Planning Board Meeting

October 17, 2023

ASSISTANT PLANNERS REPORT

ASSISTANT PLANNER REPORT

"THIS SITE PLAN APPROVAL DOES NOT NECESSARILY
INDICATE COMPLIANCE WITH THE WESTPORT ZONING BY-LAW"

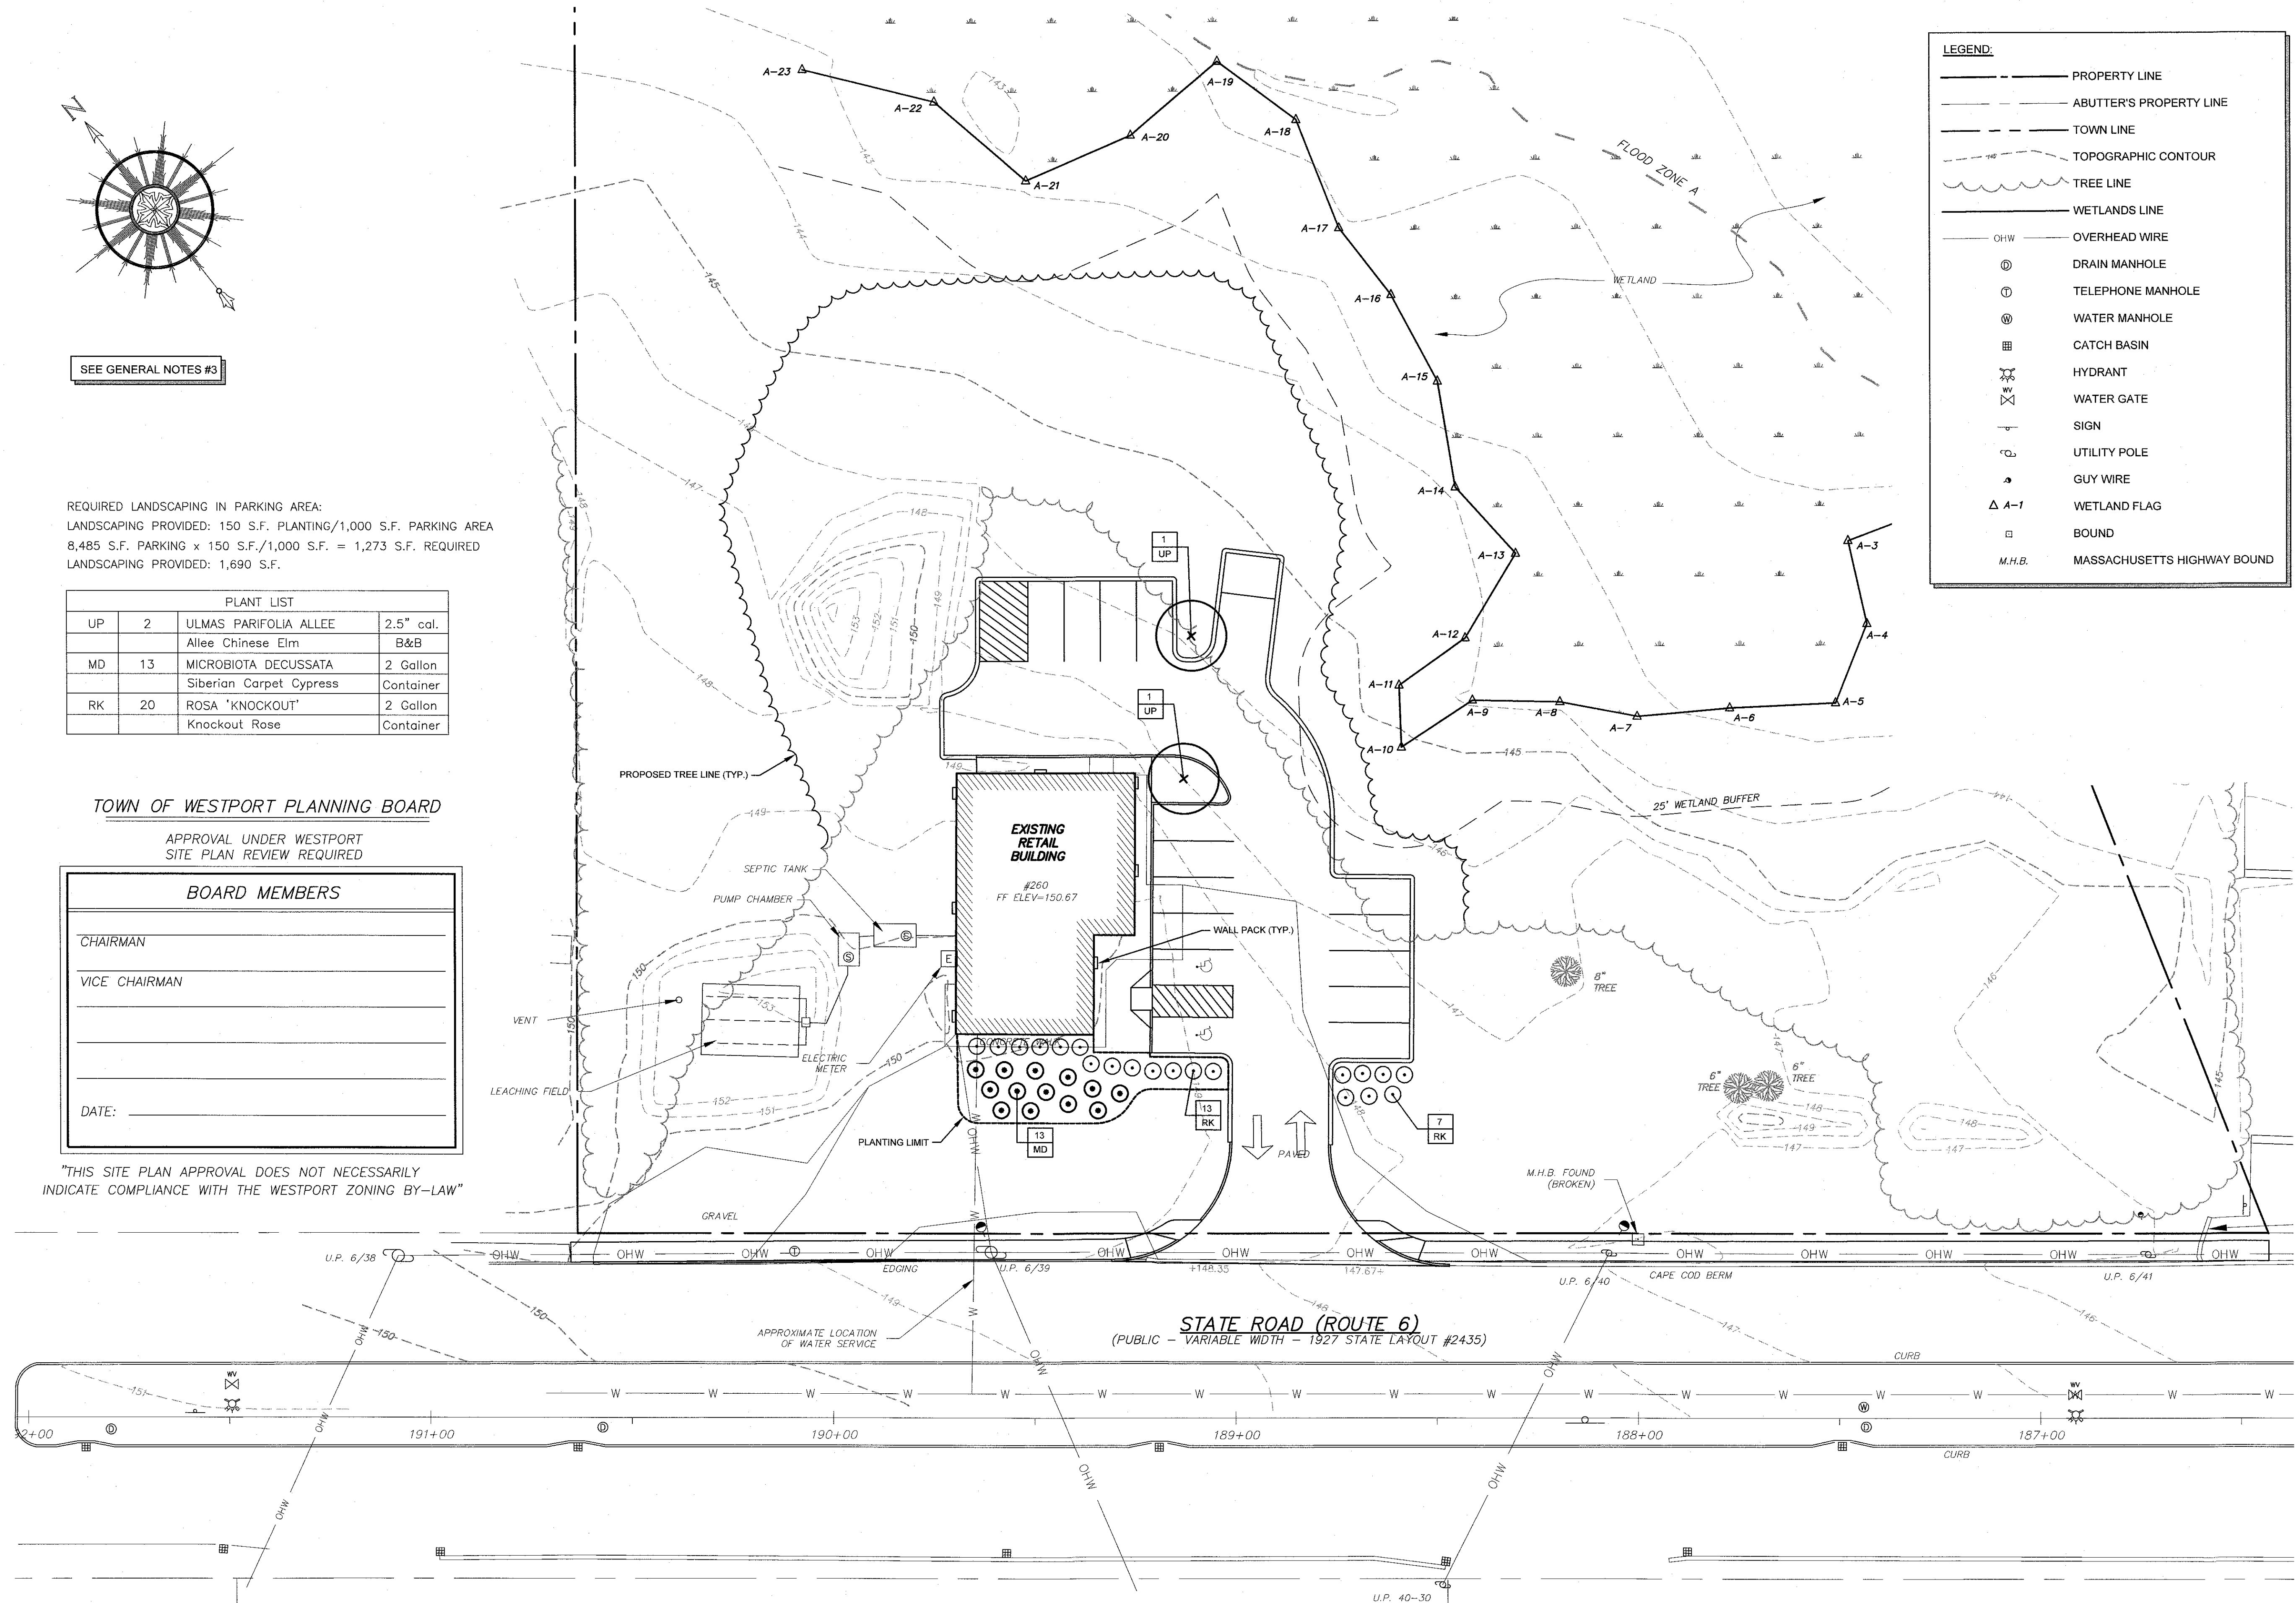
- **Wall pack lighting is to be located at strategic locations on the building for safe vehicular and pedestrian movement during hours of low sunlight and darkness. Model details of lighting should be provided to the Planning Office.**
- **Sidewalks are also present along State Road that further allows safe pedestrian movement onto and off the site. Sidewalk should be connected from the business to the sidewalk network.**
- **A bus stop is located a few hundred feet down State Road from the site, which will also allow for the safe movement of people wishing to enter or exit the bus from that location.**

- **Fire control for the building via fire hydrants on State Rd. (approximately 200' to the west and 260' to the east). Access to the building shall be via a new access drive and aisle to east and north of the building as well as State Road. **The applicant still needs to provide the Fire Department and Building Department with a code synopsis before the Fire Dept. will sign off on the project design.****
- **Utilities will be above ground**
- **Stormwater drainage calcs are included in the submission to address runoff associated with the site and impervious surface areas.**

- **No removal of stone walls is proposed as there are no stone walls located on site.**
- **Stormwater flow and drainage calcs have been provided to account for flooding, and other impacts of stormwater and soil erosion. **A temporary erosion control plan for construction should be provided, especially in the areas closest to the BVW.****
- **The site is located on State Road and all business will be conducted within the building, therefore noise and light pollution will not be factors for this proposal.**
- **The Conservation Commission noted that the proposed design is closer than the 25' to the BVW than is recommended and stated that the site has a history 21E site clean-up as the former "Beanos Garage".**

- This site is located along State Road (Rte. 6) which is located in the business district and has an extensive amount of automobiles traveling along the corridor already.
- The proposed parking is to the side and rear of the building which will help minimize light intrusion and the glare from headlights facing the State Road.
- The applicant has provided a landscaping plan depicting shrubs and greenery along the front of the building and parking lot to provide screening from the roadway. **The trees on the existing landscaping plan are 2.5" caliper, the trees should be 3" caliper.**
- **The landscaped buffer of the parking lot should be 20' deep, the current plan depicts a 10' depth.**
- **The landscaping plan should include tree plantings along the roadway.**

- The location of the dumpster pad/ enclosure on the plan is located to the rear of the site and adequately away from the entrance of the building and view from the roadway. **Enclosure materials for the dumpster area should be provided to the Planning Office and listed on the plan.**

Staff Recommendation: Staff recommends that the project be continued to a date and time certain in order receive the consultant review from S.W. Cole and address outstanding items as mentioned in this report and any items mentioned in S.W. Cole's review. The applicant will need to revise plans and provide further information.
